State of New Mexico
 Energy, Minerals and Natural Resources

Form C-103
 Revised July 18, 2013

WELL API NO. 30-025-30147
5. Indicate Type of Lease STATE <input type="checkbox"/> FEE <input type="checkbox"/>
6. State Oil & Gas Lease No. V00654
7. Lease Name or Unit Agreement Name State 2
8. Well Number #1
9. OGRID Number 142072
10. Pool name or Wildcat "Shipp" Strawn

PROPOSED P&A WELLBORE DIAGRAM

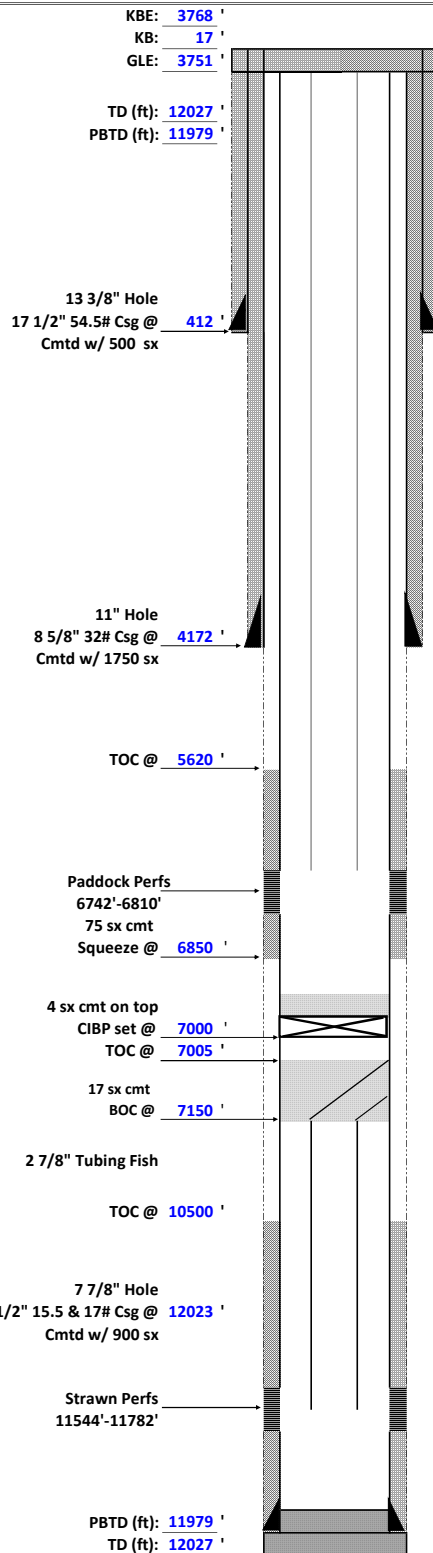
KPK is proposing to plug and abandon the State 2 #1. This well was completed in the Paddock in 2019 and no commercial production has been established. The well is currently plugged back with a CIBP @ 7000' with 4sx of cement on top. **Spot 25 sx Class C**

To plug the well, KPK is proposing setting a CIBP above the Paddock perforations @ 6690' with ~~4s~~^{35'} cement on top. Then KPK will perf @ 4222', set a CIBP @ 4172' and pump ~~30~~⁵⁰ sx of cement. Finally, we will perforate at 50' and pump 14 sx of cement to fill inside the 5 1/2" casing as well as the annulus between the 8 5/8" casing and the 5 1/2" casing. A current wellbore diagram and an intended P&A wellbore diagram have been attached to this form. **P&S 50 sx Class C 450'**

KPK expects to commence operations by 10/31/2021. **P&S 100 sx Class C 150' circ cement to surface all strings**

Note changes to procedure

4" dia 4' tall above ground marker
